**REPORT TO GEORGES RIVER COUNCIL  
LPP MEETING OF THURSDAY, 18 MARCH 2021**

<b>LPP Report No</b>	<b>LPP005-21</b>	<b>Development Application No</b>	<b>DA2020/0144</b>
<b>Site Address &amp; Ward Locality</b>	192 - 196 Princes Highway, Kogarah Bay Kogarah Bay Ward		
<b>Proposed Development</b>	Demolition works and construction of a residential flat building		
<b>Owners</b>	Kogarah Bay Property Pty Ltd		
<b>Applicant</b>	Anthony Charbel		
<b>Planner/Architect</b>	Architect: Bureau SRH, Planner: Planning Ingenuity		
<b>Date Of Lodgement</b>	23/04/2020		
<b>Submissions</b>	Nil		
<b>Cost of Works</b>	\$9,543,602		
<b>Local Planning Panel Criteria</b>	Ministerial Direction – Residential Flat Building		
<b>List of all relevant s.4.15 matters (formerly s79C(1)(a))</b>	Environmental Planning and Assessment Act 1979, Environmental Planning and Assessment Regulation 2000, State Environmental Planning Policy No. 55 Remediation of Land, State Environmental Planning Policy No. 65 – Design Quality of Residential Apartment Development, State Environmental Planning Policy (Infrastructure) 2007, Greater Metropolitan Regional Environmental Plan No 2 – Georges River Catchment, State Environmental Pla

**Figure 13** - Extract of western side elevation of the subject site which will face the northern side elevation of 198-200 Princes Highway, Kogarah Bay. Levels 4 and 5 comprise of living rooms and screened balconies (Source: Bureau SRH, 2020).

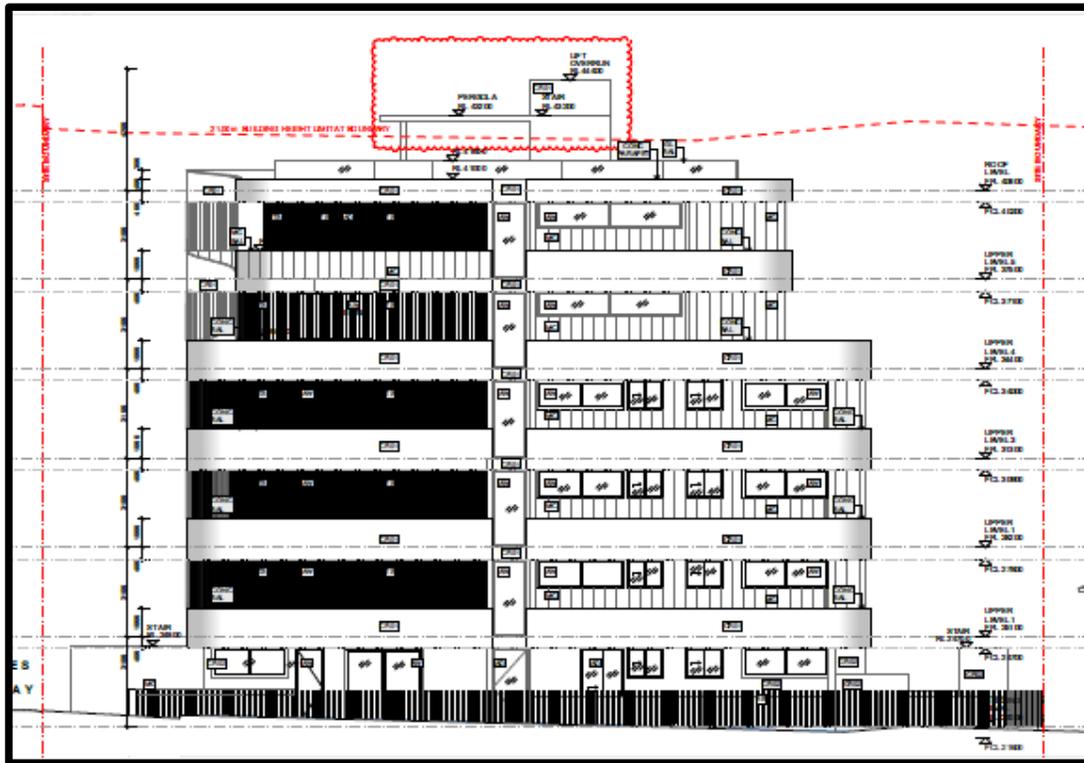
43. The proposal seeks a variation to the minimum 9m side separation distances to the fourth, fifth and sixth levels as required by the ADG. The building has been designed to be modulated and articulated at every level; however levels 4, 5 and the rooftop level 6 are proposed to be setback 6m to 7.6m from the western side boundary. This achieves a spatial separation of 12m (min) between the site and the approved residential flat building at 198—200 Princes Highway, Kogarah Bay. 18m is the required separation distance for these levels.

44. This variation has been considered and is not supported for the following reasons:
